CITY OF VAN METER, IOWA
VAN METER COMMUNITY SCHOOL DISTRICT
BUILDING ADDITION AND RENOVATION
SITE PLAN REVIEW

On April 8, 2014, the writer received from Clapsaddle-Garber Associates, Inc. the following documents constituting the site plan for the Van Meter Community School District Building Addition and Renovation project:

FACILITIES MASTER PLAN
 VAN METER
 COMMUNITY SCHOOLS
 VAN METER, IOWA

ISSUE DATE	ISSUE TITLE
Mar. 21, 2014	
REVISION DATE	REVISION TITLE
XX-XX-XX	PROJECT MILESTONE
JOB NUMBER	1092
SHEET NAME	Base Bid Grading Plan
SHEET NUMBER	C.300

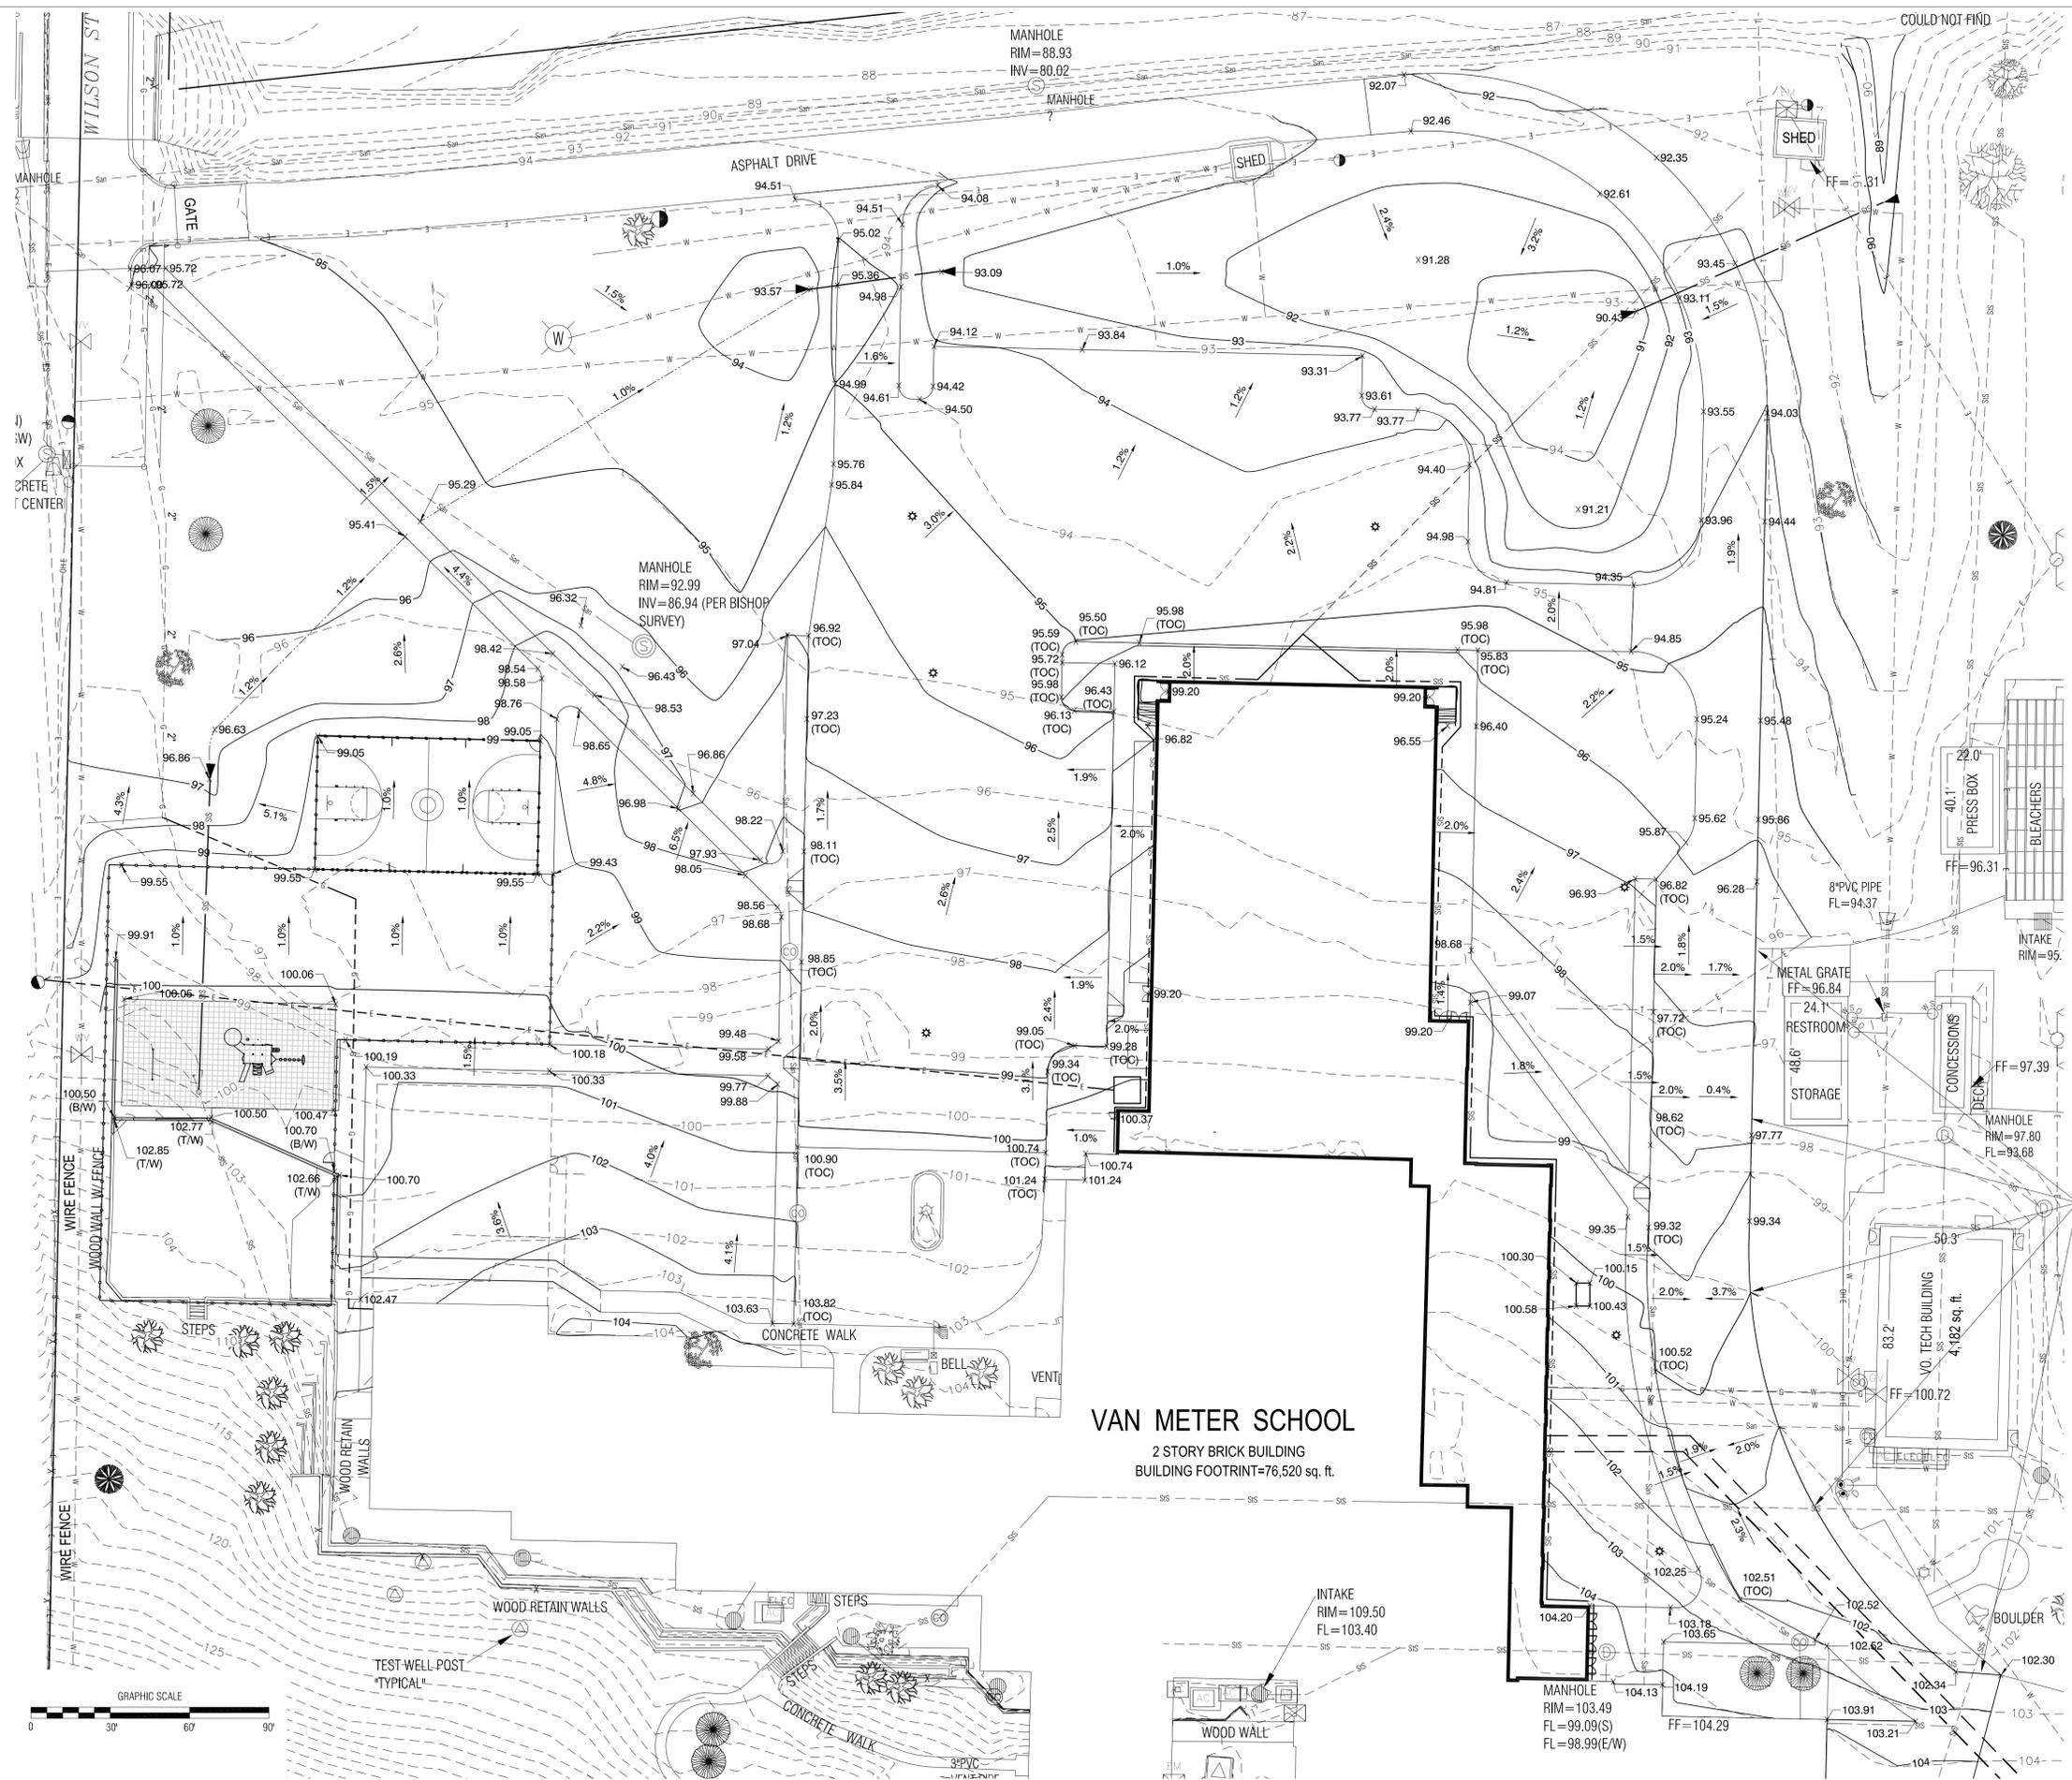
21. The new site plan includes a dry bottom stormwater pond located between the new driveway around the east and northeast quadrant of the site and the northeast corner of the new parking lot.

22. Portions of the existing site and the disturbed areas impacted by construction are graded to drain to the stormwater pond through a combination of storm sewer pipes and overland flow channels. A review of the site grading would indicate the site drains toward the stormwater pond as indicated in the stormwater drainage report.

40. The stormwater pond indicated an effective storage volume of 36,623 cf. The bottom elevation of the pond is 90.5 and the maximum ponding elevation in a Q_{100} event is shown to be 93.04 feet, or a maximum water depth of approximately 2.54 feet.

41. The outlet from the stormwater pond is an 18-inch diameter pipe flowing at 11.36 cfs under a 100 year storm event.
42. The stormwater drainage report indicates the pond will overtop by approximately 0.7 feet under a Q_{100} event.

SHEET NAME: POLLUTION PREVENTION PLAN

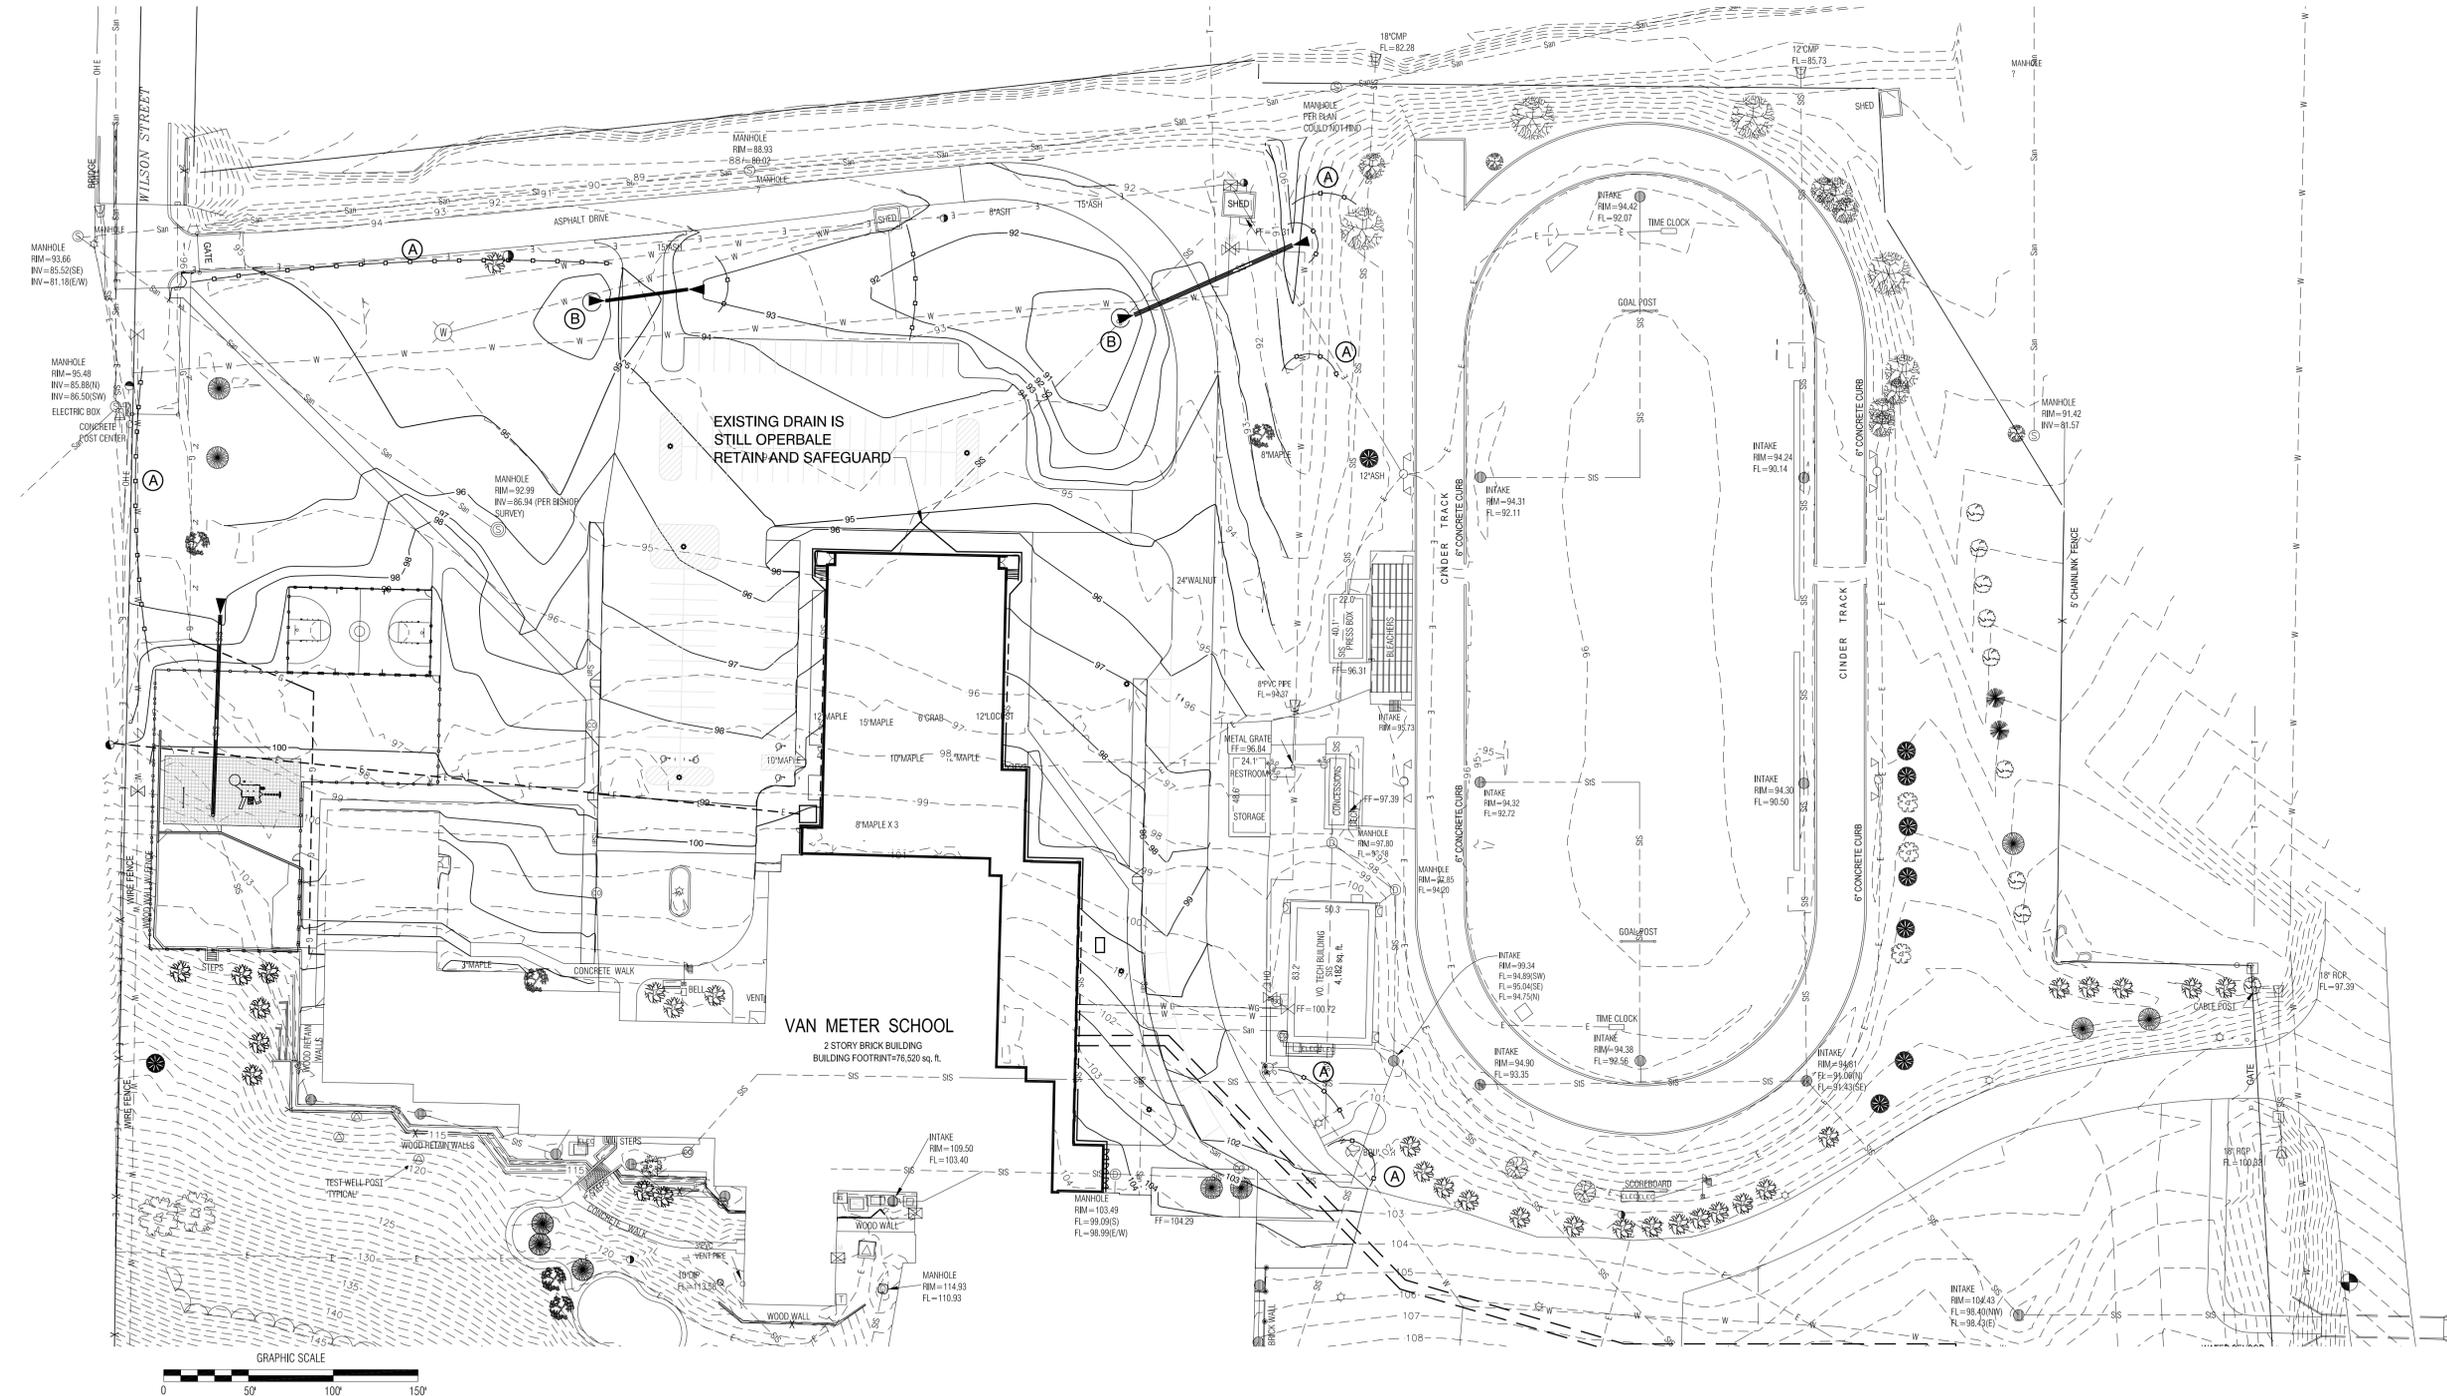
23. The site plan includes a Stormwater Pollution Prevention Plan. The Stormwater Pollution Prevention Plan includes the necessary details required for a SWPPP and illustrates the initial location of erosion control devices including silt fence and filter sock or inlet protection.

24. Prior to the start of construction it will be necessary for the school district to indicate it has obtained General Permit No. 2 from the Iowa Department of Natural Resources.

25. While the City will request a copy of General Permit No. 2 the City will not review or comment on the substance of the SWPPP.
26. The City of Van Meter does not have a stormwater permit and does not have required inspections. The City will not be conducting any regularly scheduled inspections of the Stormwater Management Plan Compliance with General Permit No. 2 will rest solely with the school district, its representatives and contractor.
